## PRODUCT/PROCESS CHANGE NOTICE (PCN)

PCN #: **TB1503-01 (R1)**      DATE: **October 23, 2015**  
 Product Affected:    **TSSOP-20, TSSOP-24, TSSOP-28,**  
                               **TSSOP-48, TSSOP-56, TVSOP-48**  
                               **SOIC-28, SSOP-20, SSOP-28,**  
 (Refer to Attachment II for affected part# shipped in Reel)  
 Date Effective:        **February 1, 2016 Earliest Date - Refer to**  
                               **specific date by package type**

### ATTACHMENT I - PCN #: TB1503-01 (R1)

Figure 1: Additional Label pasted on ESD/Moisture barrier bag and Pizza box

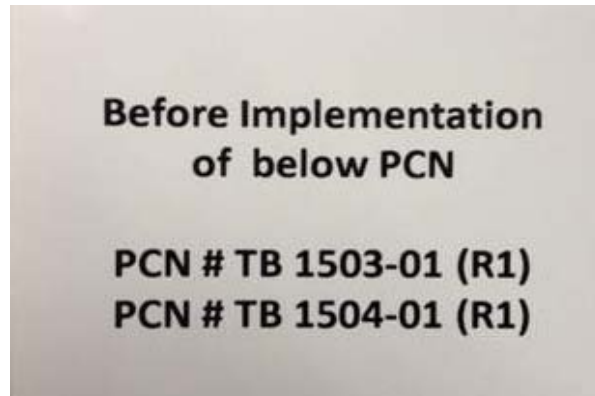
Customers may expect to receive shipments of products in new packing no sooner than 90 days from the date of this PCN notification. Shipments to customers may contain products shipped with either the existing packing or new packing during the transition period. Shipments made in the existing packing after the PCN becomes effective will have an additional label pasted on the ESD/moisture barrier bag and pizza box.

#### Illustration of Carrier Tape Pocket Design Change

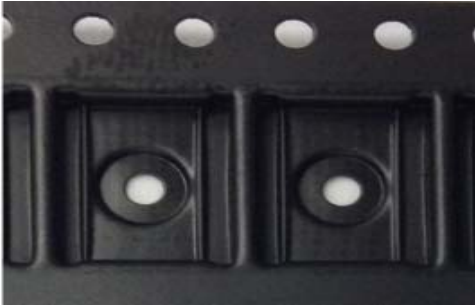
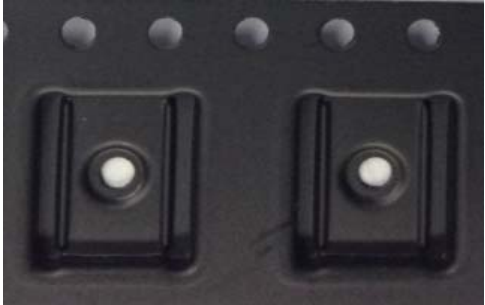
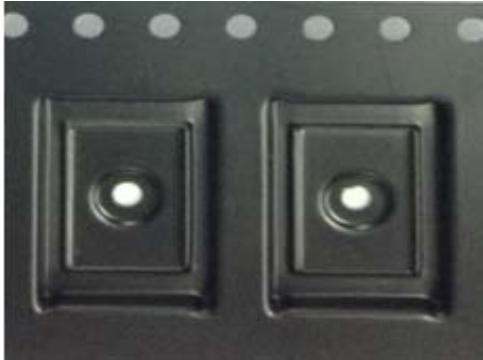
Package	From	To
TSSOP-20	Carrier Tape Part# P8-464-000 	Carrier Tape Part# P8-291-P20 
TSSOP-24	Carrier Tape Part# P8-329-P24 	Carrier Tape Part# P8-169-P24 
TSSOP-48	Carrier Tape Part# P8-260-P48 	Carrier Tape Part# P8-324-P48

#### Illustration of Carrier Tape Pocket Design Change

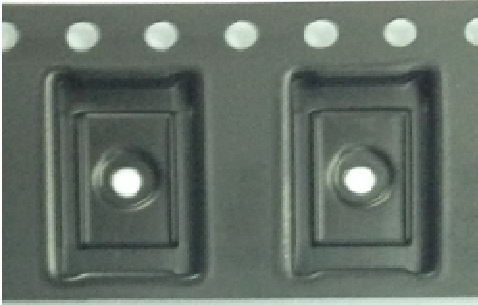
Package	From	To
SOIC-28	Carrier Tape Part# P8-187-S28 	Carrier Tape Part# P8-370-P28 
TSSOP-28 and TVSOP-48	Carrier Tape Part# P8-145-PF8 	Carrier Tape Part# P8-330-P48 
TSSOP-56	Carrier Tape Part# P8-261-P56 	Carrier Tape Part# P8-314-P56

#### Illustration of Carrier Tape Pocket Design Change

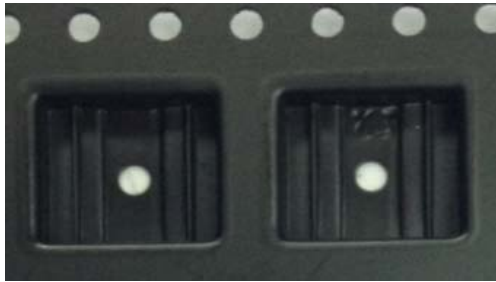
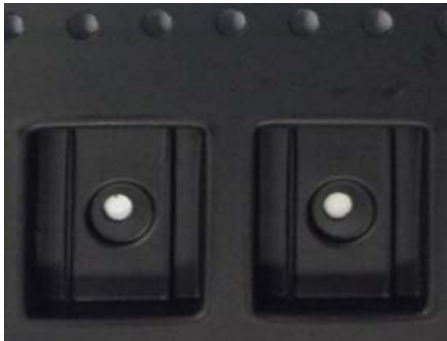
Package	From	To
SSOP-20	Carrier Tape Part# P8-259-P20 	Carrier Tape Part# P8-320-P20 
SSOP-28	Carrier Tape Part# P8-384-P28 	Carrier Tape Part# P8-321-P28
